ORIGINATION FORM

Proposed Revisions to a Standard Plans Index

Index Number: 400-010

Index Title: Cantilever Retaining Wall (C-I-P)

TYPICAL BACKFILL DETAIL

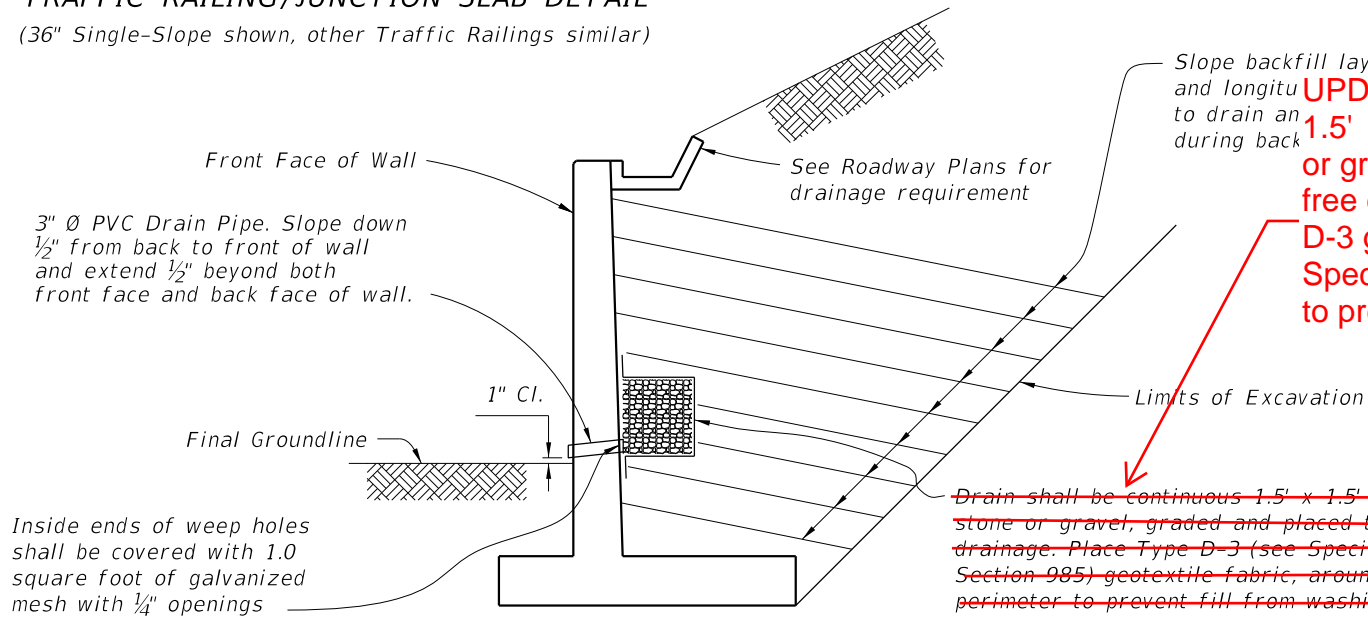
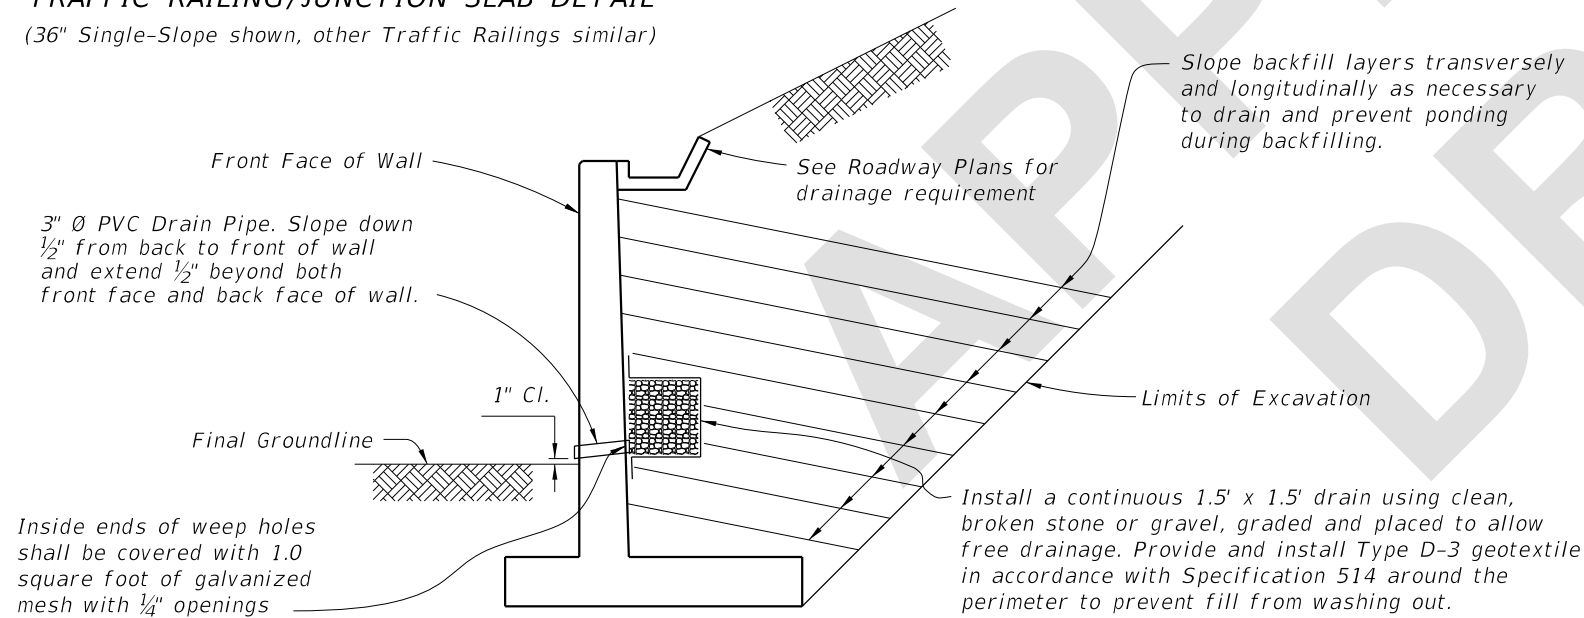
Sheet 2: Updated the TYPICAL BACK-FILL DETAIL Callout: " Install a continuous 1.5' x 1.5' drain using clean, broken stone or grave, graded and placed to allow free drainage. Provide and install Type D-3 geotextile in accordance with Specifications 514 around th perimeter to prevent fill from washing out."

~~Drain shall be continuous 1.5' x 1.5' clean, broken stone or gravel, graded and placed to allow free drainage. Place Type D-3 (see Specification Section 985) geotextile fabric, around the perimeter to prevent fill from washing out.~~

UPDATED: Install a continuous 1.5' x 1.5' drain using clean, broken stone or grave, graded and placed to allow free drainage. Provide and install Type D-3 geotextile in accordance with Specifications 514 around th perimeter to prevent fill from washing out.

SECTION A-A
EXPANSION JOINT DETAIL

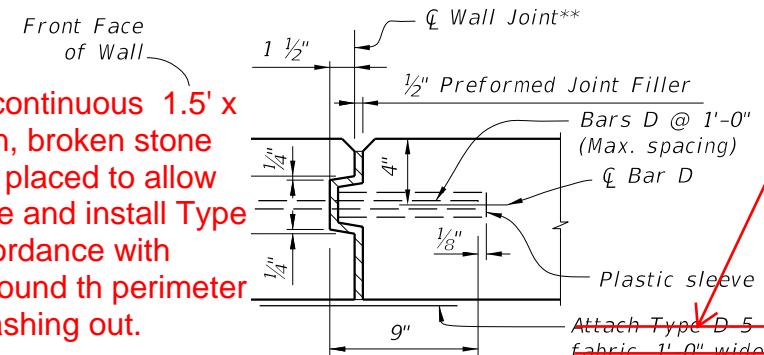
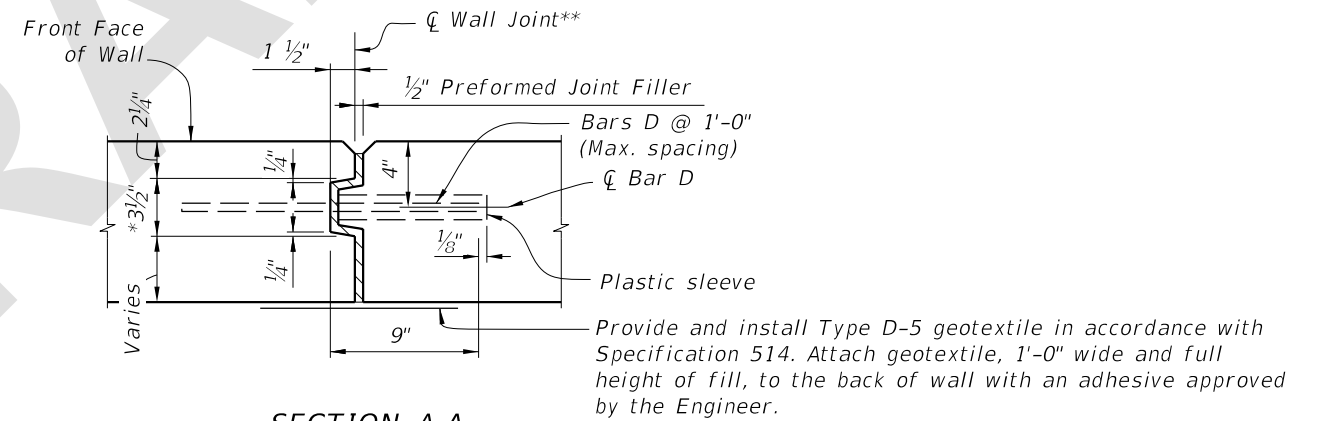
Updated the EXPANSION JOIND DETAIL (SECTION A-A) Callout: "Provide and install Type D-5 geotextile in accordance with Specifications 514. Attach geotextile, 1'-0" wide and full height to fill, to the back of wall with an adhesive approved by the Engineer."

~~Attach Type D-5 (see Specification Section 985) Geotextile fabric, 1' 0" wide and full height of fill, to the back of wall with an adhesive approved by the Engineer.~~

UPDATED; Provide and install Type D-5 geotextile in accordance with Specifications 514. Attach geotextile, 1'-0" wide and full height to fill, to the back of wall with an adhesive approved by the Engineer
